# UNITED STATES PATENT AND TRADEMARK OFFICE

<b>Office Action Summary</b>	<b>Application No.</b> 10/803,051	<b>Applicant(s)</b> PLANTAN, RONALD S.	
	<b>Examiner</b> Melody M. Burch	<b>Art Unit</b> 3657

## **DETAILED ACTION**

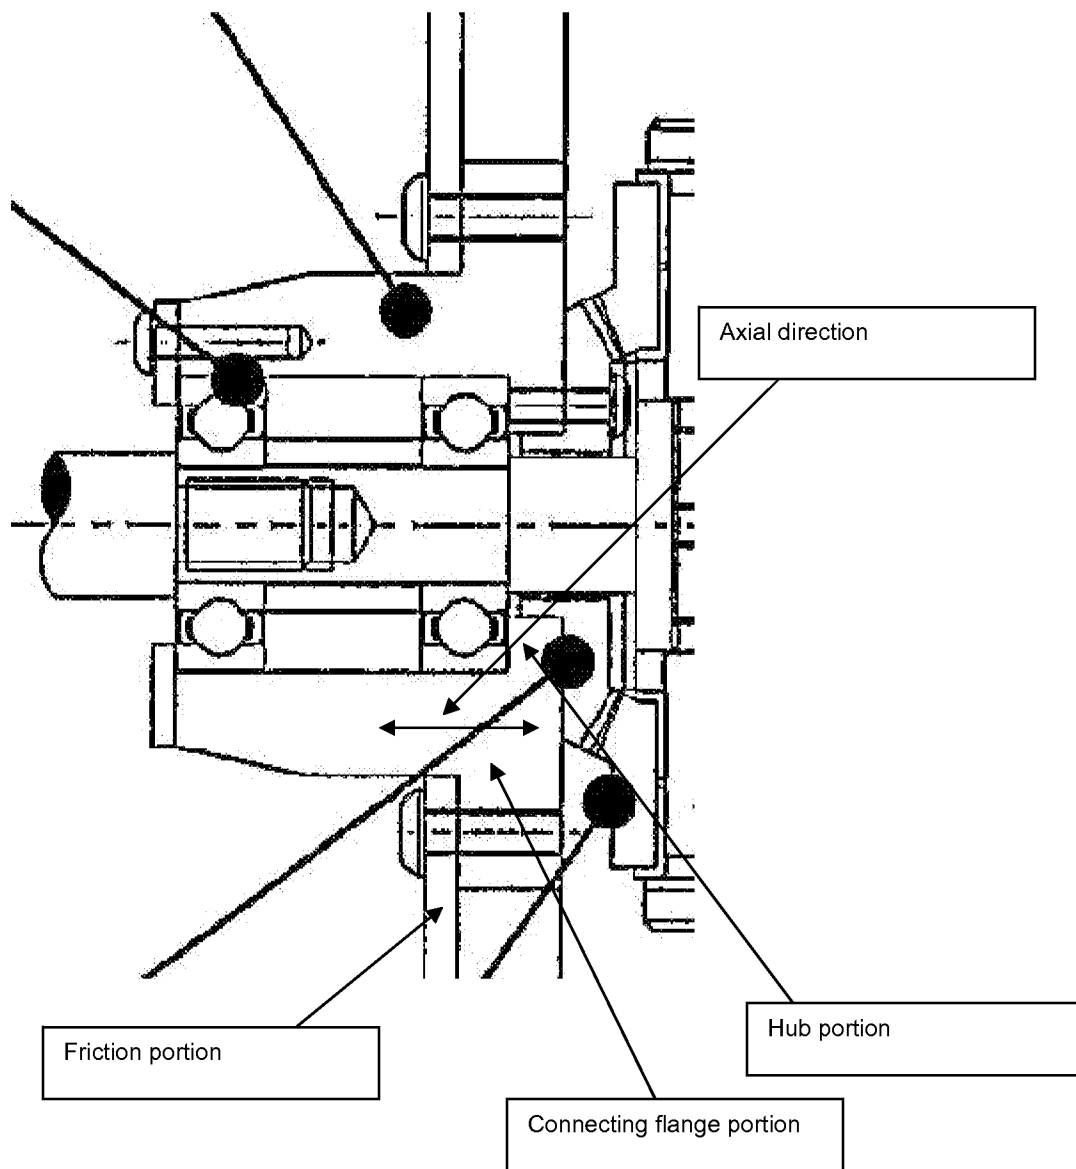
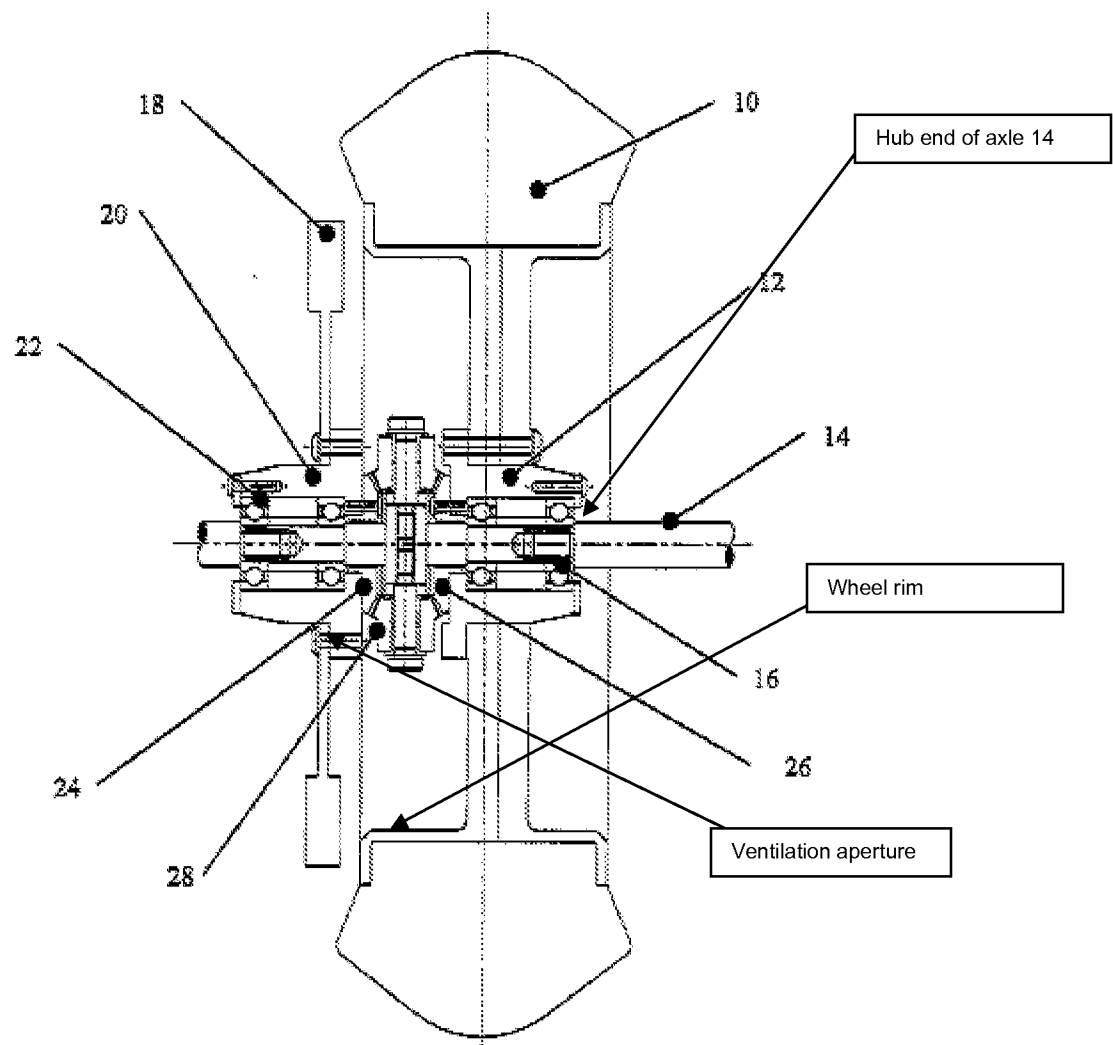
Re: claims 1-3. Simmons shows in figure 5 a brake disc 18 comprising a hub portion shown immediately to the left of the circle at the end of lead line 24, a friction portion shown in the area of the circle at the end of element number 18, the friction portion formed as a generally planar ring and a connecting flange portion shown in the

Re: claims 4-6. Simmons in figure 5 shows an at least one heat-conduction limiting section or reduced thickness shown at the bottom of the portion shown in the area of the end of the lead line of number "18".

Re: claims 7-9. Simmons shows in figure 5 at least one ventilation aperture as labeled in the annotated figure provided in this Office action.

Re: claims 17-19. Simmons, as modified, teaches in figure 5 of Simmons an at least one heat-conduction limiting section or reduced thickness shown at the bottom of the portion shown in the area of the end of the lead line of number "18".

Re: claims 20-22. Simmons, as modified, teach in figure 5 of Simmons at least one ventilation aperture as labeled in the annotated figure provided in this Office action.
